STAFF REPORT
COMMUNITY DEVELOPMENT DEPARTMENT

HEARING DATE: 8/9/2022
TO: Mayor & City Council
FROM: Sonya Allen, Associate Planner
208-884-5533
SUBJECT: FP-2022-0014
Outer Banks – FP
LOCATION: Generally located at the southwest corner of W. Franklin Rd. & S. Ten Mile Rd. at 75 S. Ten Mile Rd., in the NE 1/4 of Section 15, T. 3N., R.1E.

Final plat consisting of 24 building lots and two (2) common lots on 36.07 acres of land in the R-40 and C-C zoning districts for Outer Banks subdivision.

Job No. 21-574
Sheet 3 of 6

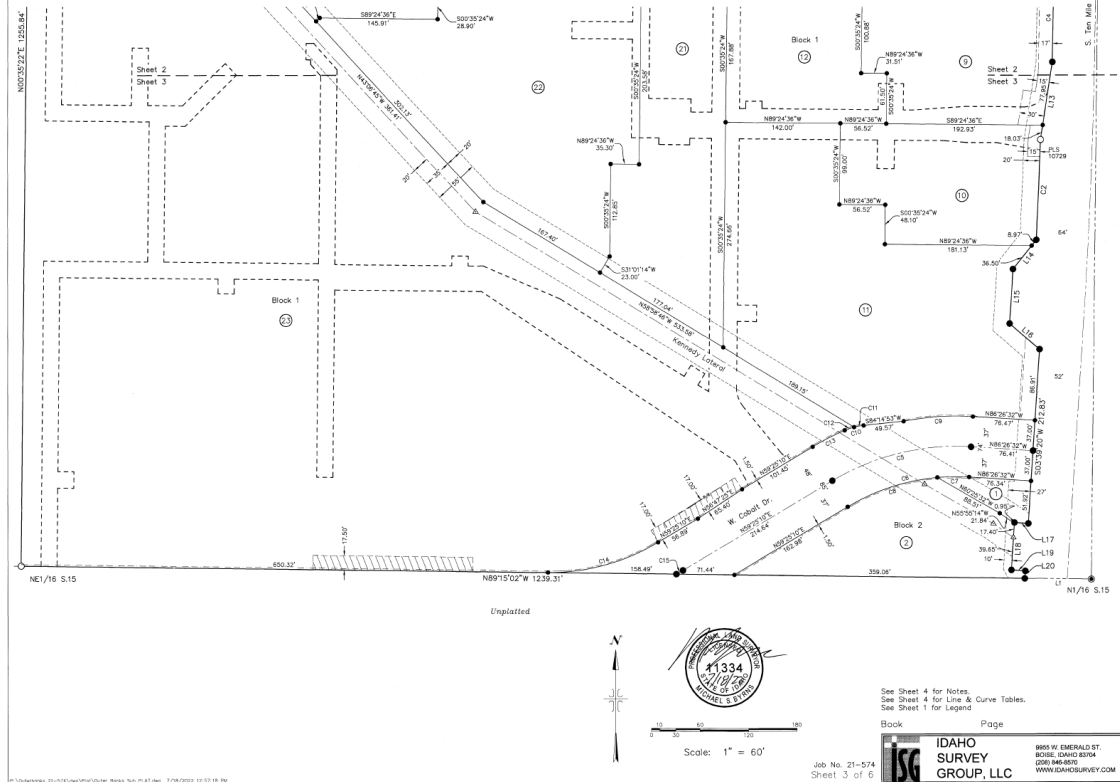
- a. Note #5: Include W. Cobalt Dr. in the note.
 - b. Graphically depict all street buffers in a common lot or on a permanent dedicated buffer with a note stating they shall be maintained by the property owner or business owners' association, as set forth in UDC [11-3B-7C.2b](#). *Required street buffers are as follows: minimum 25-feet wide along W. Franklin Rd., an arterial street; minimum 35-feet wide along S. Ten Mile Rd., an entryway corridor; and minimum 20-feet wide along W. Cobalt Dr., a collector street. Street buffers are measured from the back of sidewalk where attached sidewalks are provided and from the back of curb where detached sidewalks are provided per UDC 11-3B-7C.1a.*

- c. The street section for Cobalt Dr. shall include (2) 11-foot wide travel lanes, 6-foot wide bike lanes, 8-foot wide parallel parking, curb, gutter, 8-foot wide planter strips (i.e. tree lawn/parkway) and detached 6-foot wide sidewalks consistent with Street Section D in the [TMISAP](#) (see Pg. 3-21). Parallel parking shall be located to the west of the horizontal curve for Cobalt Dr. and be located beyond the sight distance required for the access proposed on Cobalt Dr. as required by ACHD. **Submit street section that demonstrates compliance with this condition.**

L-3.6p
 SHEET

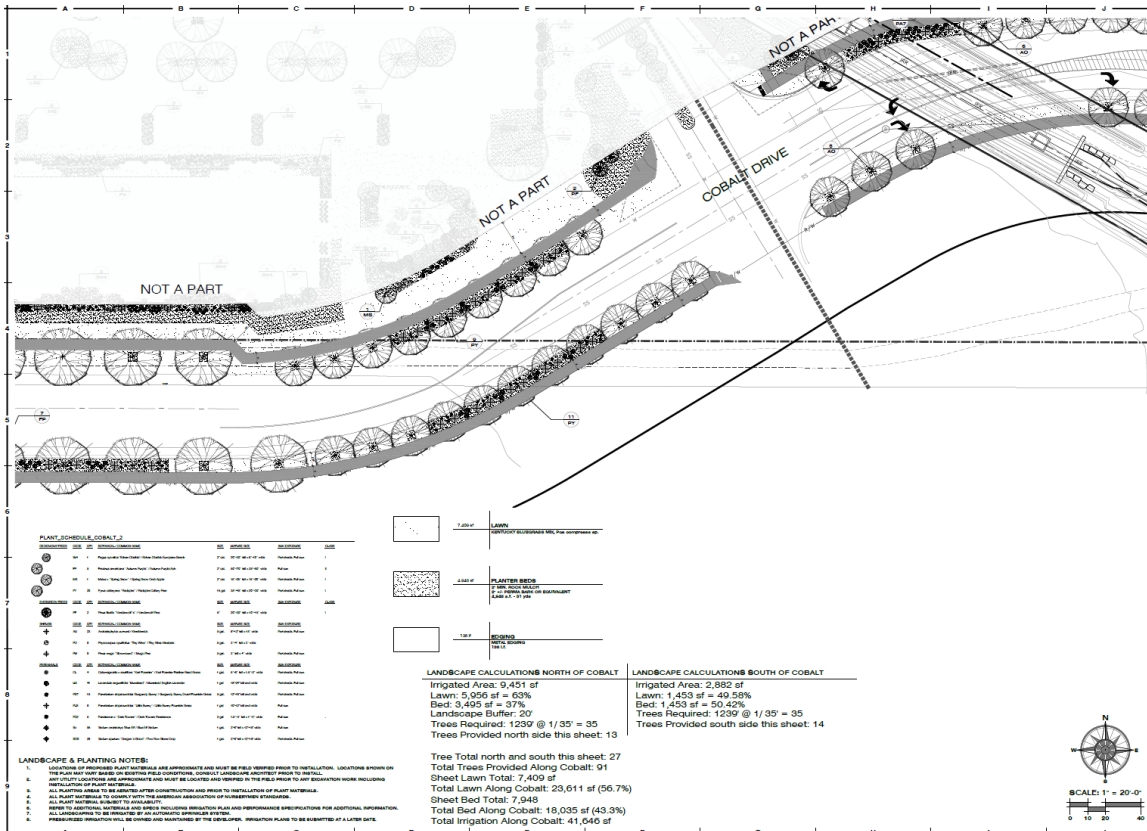
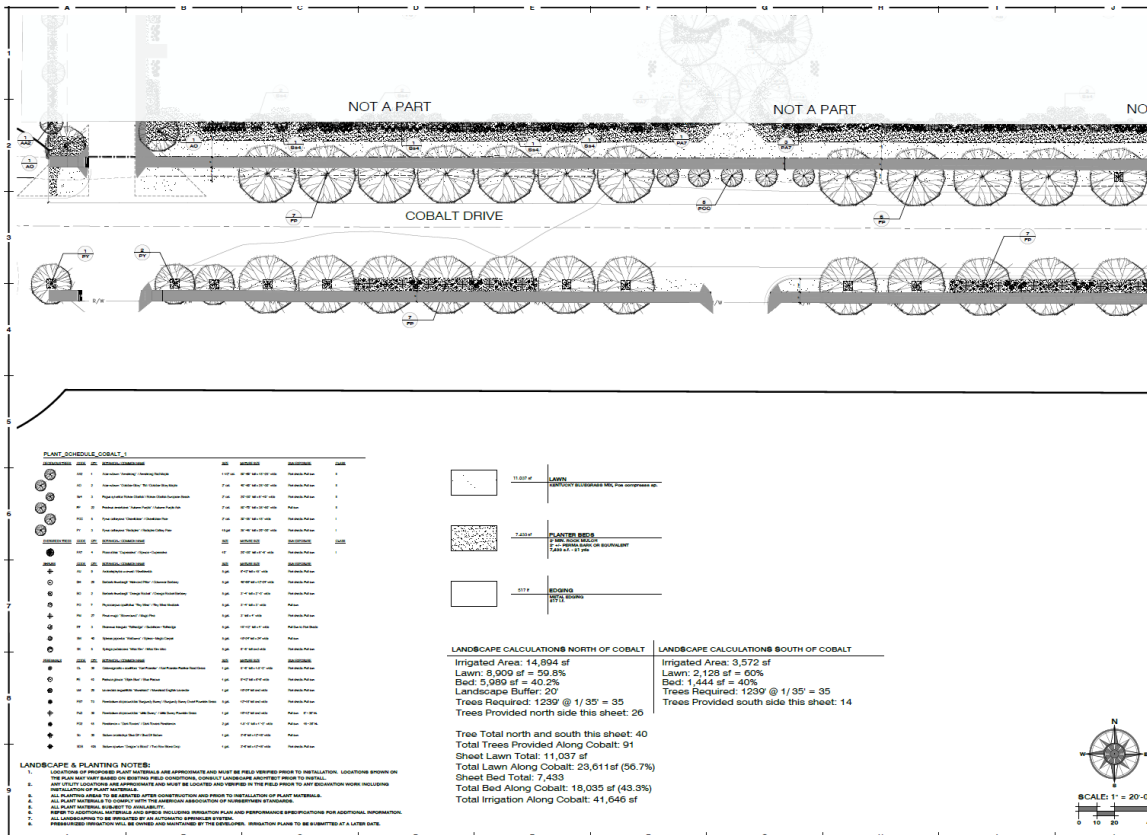
5. The landscape plan shown in Section V.C, dated 4/14/22, shall be revised as follows:
 - a. Include shrubs, along with the trees and lawn or other vegetative groundcover, *within* the required street buffers as set forth in UDC [11-3B-7C](#). The minimum required street buffer widths are as stated above in condition #4b (additional width may be provided); the correct buffer widths should be depicted in the Landscape Calculations tables.

- c. Depict & dimension a minimum 8-foot wide tree lawn along W. Cobalt Dr. with street lights in the dry utilities corridor on either side of the street consistent with Street Section D in the [TMISAP](#) (see pg. [3-23](#)). Clearly depict the location of curb and sidewalk on the plans.

OUTER BANKS SUBDIVISION MASTER SITE PLAN - PUBLIC ART LOCATIONS

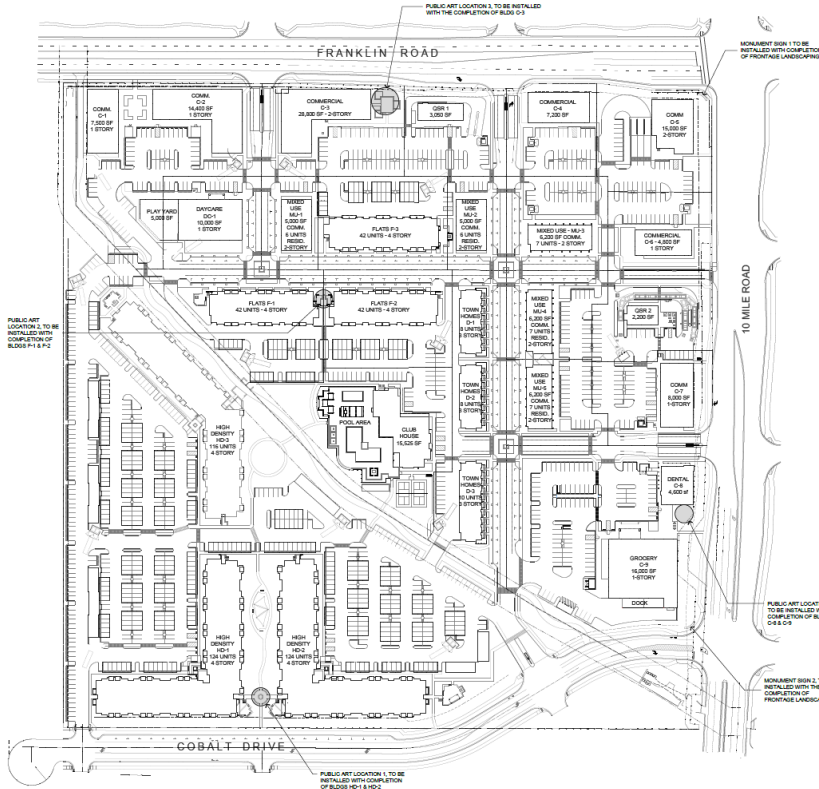
11. Public art shall be provided within the development in accord with the plan in Section V.D, consistent with the Development Agreement and the TMISAP (pg. 3-49).
